URGENT MEDICAL DEVICE CORRECTION

GEHC Ref# 32047

RE: Infant Warmer System (IWS) Hot “Heater Head” Screw could Fall onto the Bed

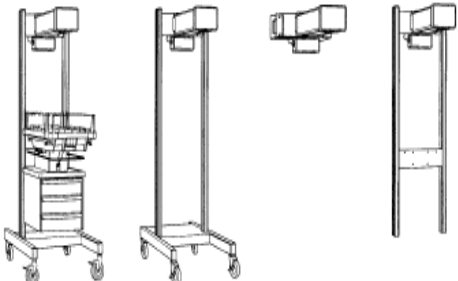
Hot screws from the “Heater Head” of the IWS could fall onto the bed if the “Heater Head” assembly has been improperly serviced. This situation can be clinically hazardous because thermal injury to a patient could result. Two injuries have been reported as a result of this issue.

As a result, if “Heater Head” service has been performed in the past, check to ensure that the screws are tightened as soon as the unit becomes available.

If the “Heater Head” assembly has not been serviced, check to ensure that the screws are tightened as part of your next regularly scheduled annual Preventive Maintenance check.

The attached Service Manual Addendum provides instructions for checking and tightening the screws. During each annual Preventive Maintenance check, continue to ensure that the screws are tight.
